CHANGE NOTICE

Effective Date: DECEMBER 1, 2012
Log Number: CN-11-442
Subject: DEPENDO DRAIN VALVE P.N. 04103.00
Models Affected: 180UC, 181, L-1X, L-1X16, GL-X

DEPENDO DRAIN VALVE

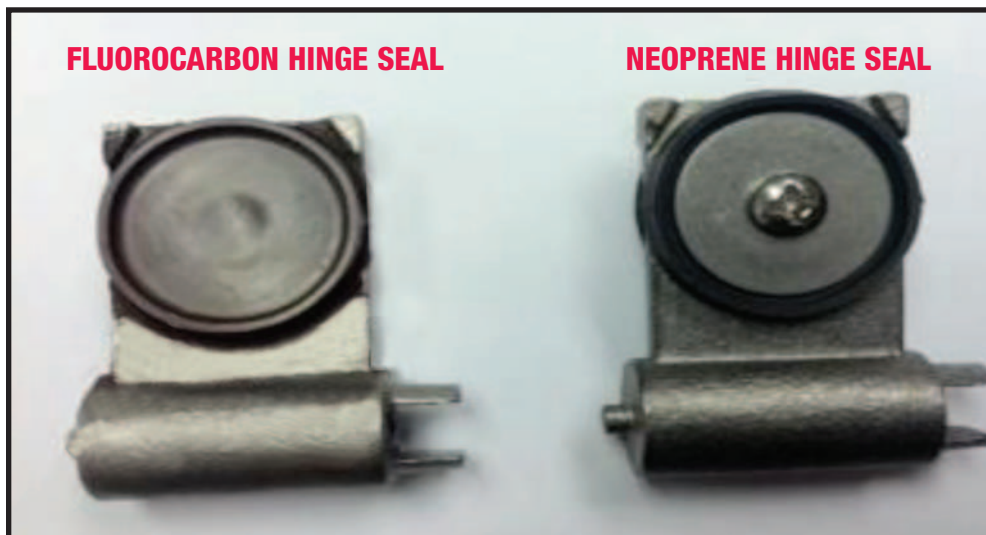
For months, CMA has been working with Dependo Drain on improving the durability of the Rubber Hinge Seal, CMA PN# 04103.00. In response to customer complaints, stating the short life of our Dependo Drains, CMA has high confidence that this change will considerably extend the life expectancy of Dependo Drains.

The new hinge presents two major improvements; the first being that the material has been changed to “Fluorocarbon”, and secondly, the seal has been bond-molded to the hinge. We believe the washer and the Neoprene material (on the older valves) contributed to some of the premature wear of the seal. The “Fluorocarbon” hinge seal material has a higher durometer rating (much stiffer), which requires a slight change, to the drain valve body, to seal properly. The “Fluorocarbon” valves are identified by a “blue” tape-wrapped drain port, which requires replacement Hinge Seal, CMA PN# 04113.16. The older valve, with the Neoprene Hinge Seal, is identified by a “yellow” tape-wrapped drain port, which requires replacement Hinge Seal, CMA PN# 04103.16. Unfortunately, the new and old Hinge Seals are not interchangeable, which brings the details in this Change Notice.

The “Fluorocarbon” hinge seal has been tested by the manufacturer for a minimum of 200,000 cycles of hot water, along with a generic brand of warewashing chemical; however, the truth is that “real world conditions” happen in the restaurant.
